RESPONSE TO PAC QUESTIONS

On 18 January 2016, Hansen Bailey forwarded a document containing a number of points of clarification relating to the second Planning Assessment Commission (PAC) review of the Russell Vale Colliery Underground Expansion Project (UEP). Wollongong Coal commissioned SCT Operations Pty Ltd (SCT) to respond to queries that relate to those areas of the project that SCT has been working on. This letter report presents SCT's response to height of depressurisation, effect of Bald Hill Claystone to affect Cataract Creek tolerance to valley closure, and contingency to manage pillar layout issues at the western end of Longwall 7. The questions numbers used correspond to the numbering in the Hansen Bailey document.

SUBJECT: Final Response to PAC Review

Figure 1: Eastern mine working plan and record tracing with proposed LW7 outline.

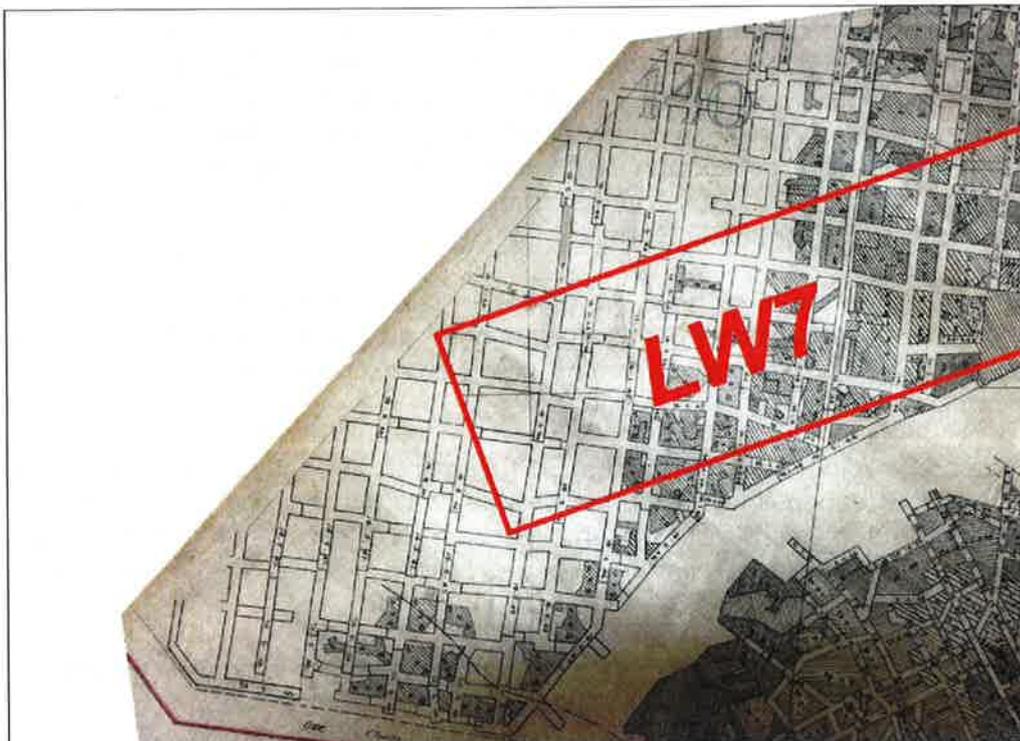
3.1 Question 19 "What contingency is proposed in the event that the reliability of the record tracing cannot be determine?"

The area in the Bulli Seam at the inbye end of Longwall 7 was mined in the period between about 1944 and 1949. Both the mine working plan and the record tracing for this area of the mine are available and have been reviewed. The mine working plan and record tracing reproduced in Figure 1 shows the dates of mining individual roadways and the individual pillar splits in areas of pillar extraction.

There is a mismatch at the boundary between two sheets of about 2m on the ISG version of the mine plan that is likely due to stretching of the medium on which the plans have been redrafted. However, this area of the mine is connected to the operating mine and the survey network is considered likely to be coherent with the known position of the main headings that are still accessible. On this basis, the actual position of the workings is expected to be accurate to within about 5 m. The relative accuracy of individual roadways and pillars is expected to be in the range of only a few metres.

The pillars shown on the mine working plan and the record tracing are large enough to be stable when Longwall 7 is mined. Some adjacent areas shown on these mine plans are shown as having been extracted. If all the area had been extracted beyond what is shown, which appears unlikely, the effect on subsidence and the protection of Cataract Reservoir from mining Longwall 7 would be slight based on experience at multiple locations of mining below areas of full extraction in the Bulli Seam.

Although the mine workings in the Bulli Seam at the inbye end of Longwall 7 are no longer accessible, SCT understands that Wollongong Coal proposes to drill boreholes to confirm that the location and nature of the workings is consistent with the mine working plan and record tracings in the area adjacent to the inbye end of Longwall 7.

Figure 1 Vertical Hydraulic Conductivity (Fracture Zone vs. Host) Over LW4

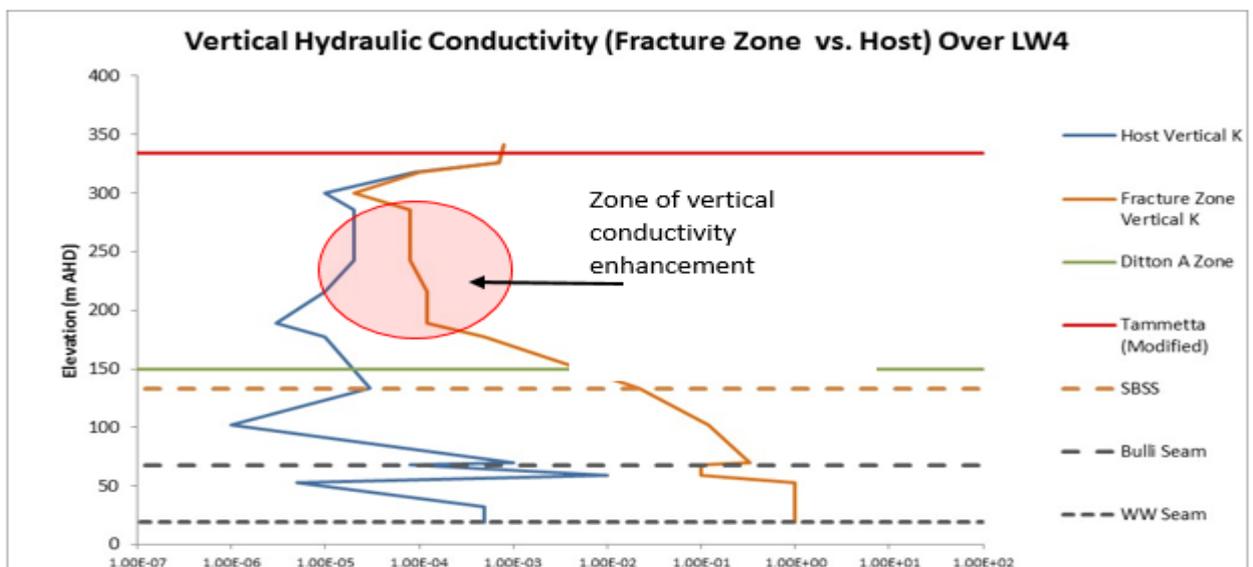
Q15 – Why was the height of the caved zone increased in areas of multi-seam mining when subsidence behaviour suggest that minimal additional voids result from extraction of second and subsequent seams that are in close proximity (that is, incremental subsidence approximates the extracted height of second and subsequent seams)

Where multiple seam extraction was conducted, the Tammetta (2012) theory was then modified by adding the cumulative thickness of all workings. This approach overestimated the height of depressurisation measured by the piezometers. Subsequently, the Ditton and Merrick (2014) theory of strata fracturing / strata depressurisation (which was also developed for single seam mining over a longwall panel) was compared to the observed VWP data, and this theory also did not reliably predict the observed height of depressurisation using a RAMP function with a linear decline of enhanced vertical conductivity (weighted layer thickness) that did not match the observed groundwater pressures in the site VWP's, primarily in the Bulgo Sandstone.

As a result, the model utilised a modified version of a vertical conductivity ramp function enhancement whereby a greater degree of enhancement was made within the Lower and Mid Bulgo Sandstone as shown in **Figure 1**.

In essence, the measured depressurisation from the suite of VWP's was used in the groundwater model set up and calibration, however they did not correlate well to the modified Tammetta (2012) (using cumulative seam thickness) theory, whilst the Ditton Merrick (2014) approach was somewhat less conservative and also wasn't used.
